Georgia Institute of Technology

MEMORANDUM

TO: Nuclear Safeguards Committee
FROM: R. A. Karam *RAK*
SUBJECT: Bismuth Block Leak and What To Do About It

PERTINENT DATA ABOUT THE BISMUTH BLOCK AND THE COOLING SYSTEM

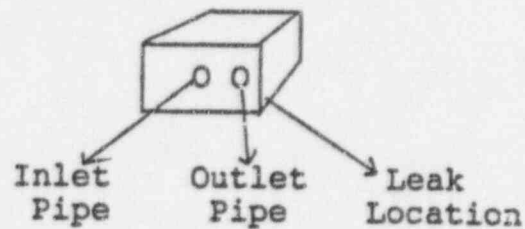
1. The radioactivity content of the bismuth block cooling water needs to be evaluated.
2. Water - Bismuth block interaction needs review. Specifically, (a) has shielding properties of the block been affected?; (b) Are there any chemical reactions between water and bismuth or water and magnesium?
3. Heat removal with reduced flow should be evaluated. Estimates of temperature rise without cooling and with 3/4 normal flow of cooling, should be made.
4. Plan a test run for approximately one hour.
5. Permanent correction to problem should be assessed.

. Location of leak in block is at lower right corner near the water outlet pipe. Note that no leak is observed at inlet or outlet pipes which are also located at lower right corner (see sketch)

- . Normal flow condition of cooling water is 1.25 gal/min
- . Maximum temperature rise in cooling water = 28°F
(Based on 4.75 MW run for 24 hours on 12/13-14/83. Water temperature into block was 75°F and out of block was 103°F)
- . Heat deposited in block = flow rate . cp . ΔT

- . Fraction of water leaking is about 25%
- . It appears that the leak location is at the outlet, thus providing full block cooling function. This observation is based on the difference in head pressure between inlet and outlet water.
- . The pH of the water which has been circulating in the cooling system for many years is 6.8.
- . The radionuclide analysis of the cooling water showed the following:

Transient Temperature Distribution In Bismuth Block Due To Heat Generation

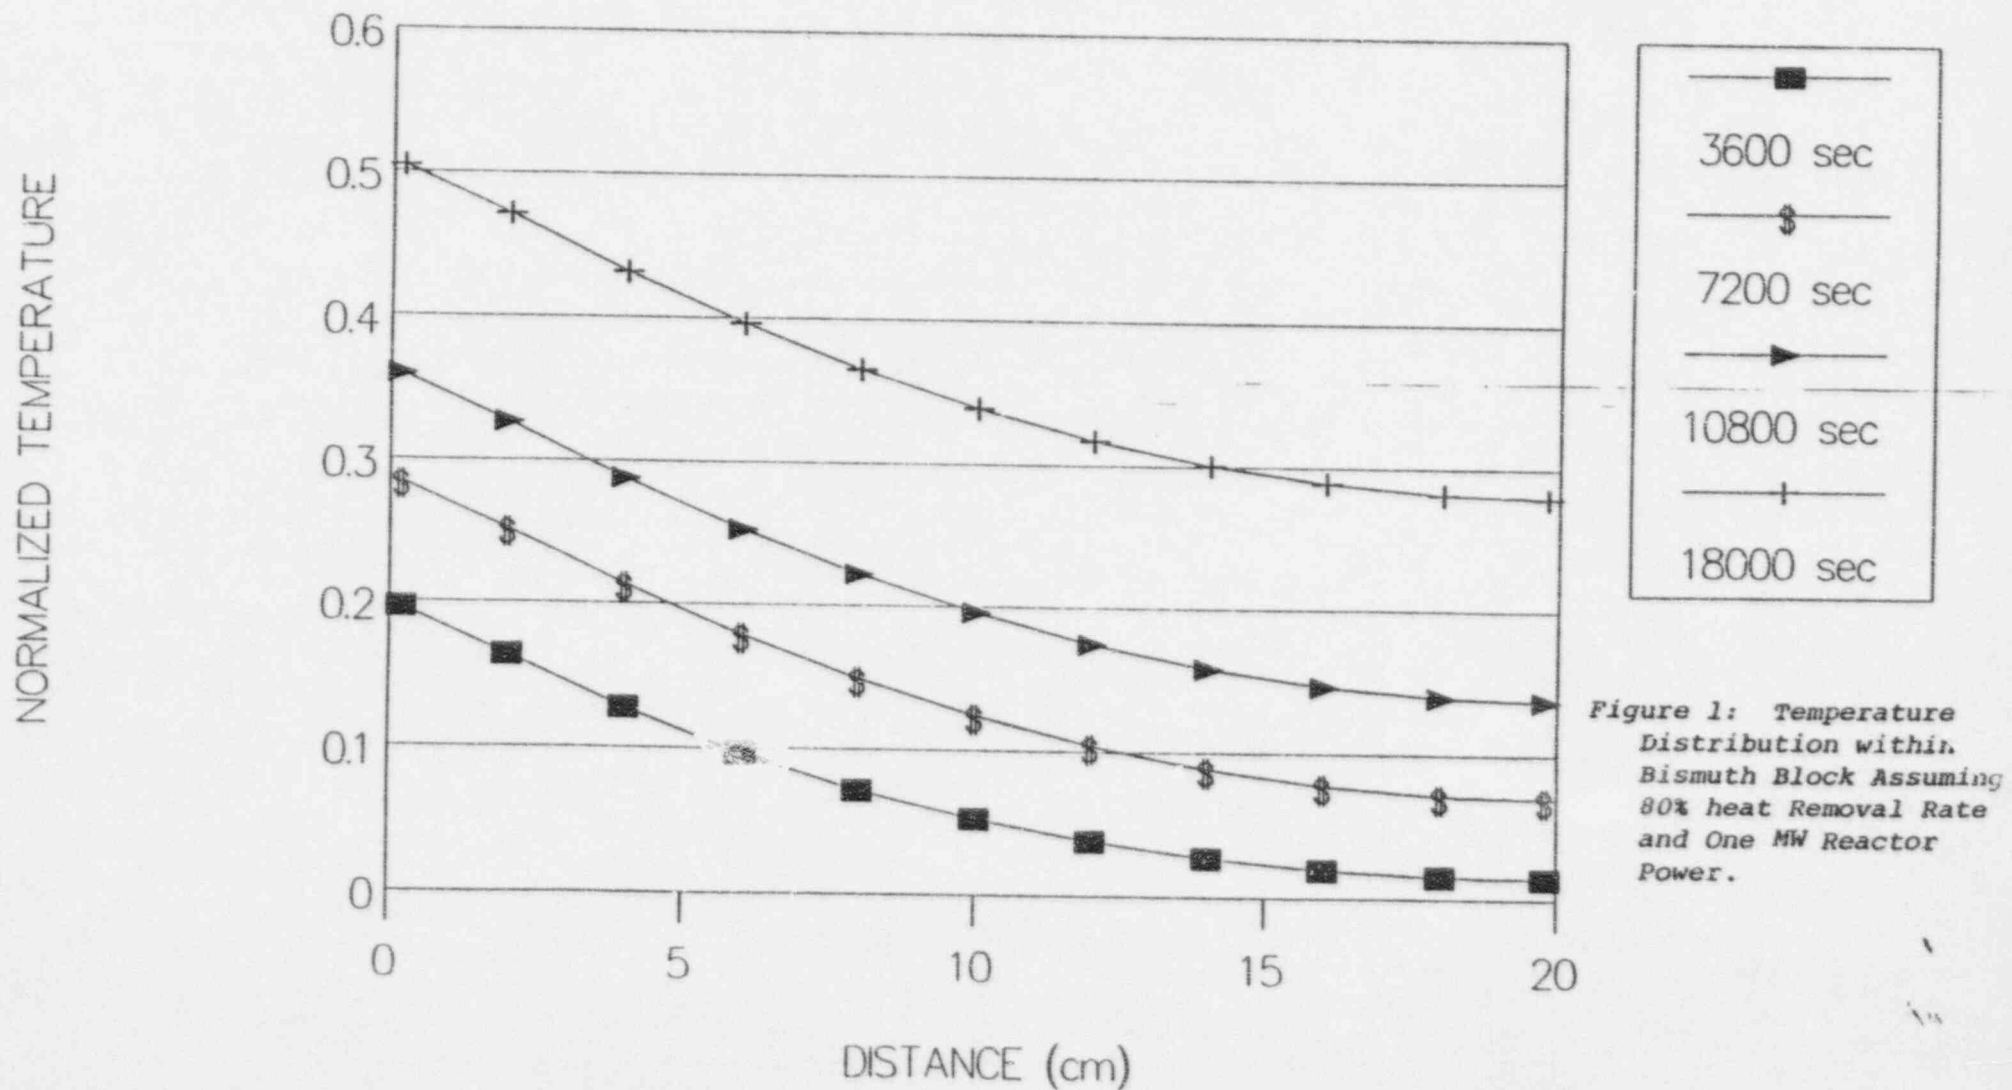
4. Heat Removal With Reduced Flow

Dr. Prateen Desai, member of the NSC, performed scoping calculations using extremely conservative assumptions. Heat loss rates were assumed at 80 or 99%. Specifically Dr. Desai solved the following equation.

The results are summarized in Figures 1 and 2. Figure 1 shows the normalized temperature as a function of distance from the inner to the outer surface of the block at various time intervals, at one MW power level assuming 80% heat removal rate. Figure 2 shows similar data but with assumption of 99% heat removal rate and one MW power level. Note that the normalized temperature reaches the melting point when $T' = 1.0$. When T' is 0.5 for example, $T = T_i + 0.5(T_m - T_i) = 30^\circ\text{C} + .5(271 - 30^\circ\text{C}) = 150.5^\circ\text{C}$.

Figure 1 shows that 5 hours of operation at one MW power level, assuming 80% heat removal rate, the temperature of the inner surface of the block would be 150.5°C . The melting point of bismuth is 271°C .

The two end walls at $X' = 0$ and $X' = 1$ are assumed to loose heat by convection at the outer surface of the block and by conduction at the inner. (Dr. Desai estimates that heat loss at the outer face by convection can be up to 1,500 BTU/hr.)
